ARCHITECTURAL REVIEW BOARD STAFF REPORT

Project #/Name	ARB-2021-104: 490 Westfield Road Comprehensive Sign Plan and Hookaholic Lounge Wall Sign
Review Type	Comprehensive Sign Plan and Certificate of Appropriateness for a Wall Sign
Parcel Identification	061W0-01-0C-00400
Location	490 Westfield Road at the intersection with Seminole Trail (Fig. 1)
Zoned	Commercial (C1) / Entrance Corridor (EC) / Airport Impact Area (AIA)
Owner/Applicant	THE 29 GROUP LLC / Hookaholic Lounge (Chadi Nassif) / American Made Signs (Brion Draper)
Magisterial District	Rio
Proposal	To establish a Comprehensive Sign Plan (CSP) for a multi-tenant building (Fig. 2) and to install a cloud-style wall sign (Fig. 3).
Context	This building, which formerly housed the Nature Conservancy, has been divided into a multi-tenant building. Two tenants have applied for signs, Sigora Solar and Hookaholic Lounge, on the south and east elevations, respectively.
Visibility	The east and south sides of the building are clearly visible from the EC (Rt. 29).

ARB Meeting Date	February 7, 2022
Staff Contact	Khris Taggart

Figure 4: Images from ARB2021-58: Sigora Solar Wall Sign Application

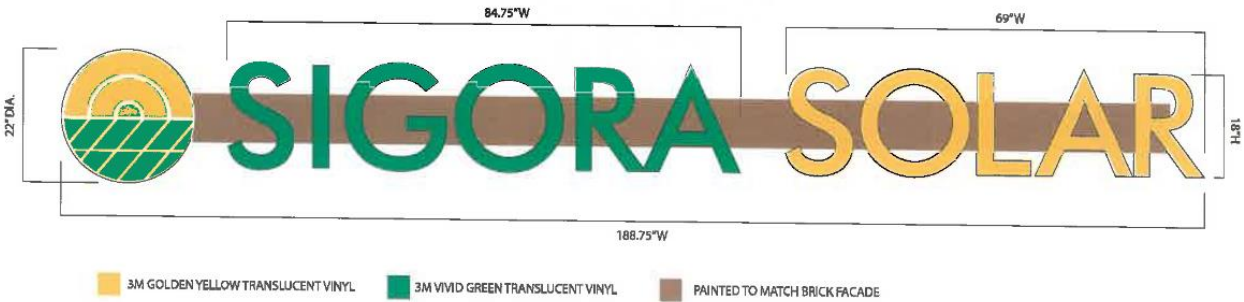
10b	b. Multiple business centers shall use a single sign type for all wall signs.		
10d	Signs must be placed on the building in a manner that establishes a unified appearance.	Two wall sign types are proposed, channel letters and 'cloud' cabinets. The "cloud" cabinet sign type does not have the appearance of individual letters that will allow the structure of the building to read through. Individual channel letters mounted on a raceway or directly to the building would be appropriate.	Revise the CSP to limit the sign type to individual channel letters.
9b	Channel lettering (mounted on a raceway or individual letters) is preferred to cabinet signs because cabinet signs tend to appear less integrated with the building. Channel letters overlay the wall material and allow the structure of the building to "read through" with less interruption. This results in a more coordinated overall appearance.

10c	c. Compatibility among signs must be maintained through color or font and typeface selection.		
9c	For raceway-mounted channel letters, the raceway shall match the wall color.	The proposal specifies that raceways are to match 19-1543 TPG Brick Red. EC standard practice is to include a general note that raceways will match the color of the wall to which they are attached.

Staff recommends that the sign type be revised to individual letters and that the design be revised to follow the recommended CSP criteria outlined below.
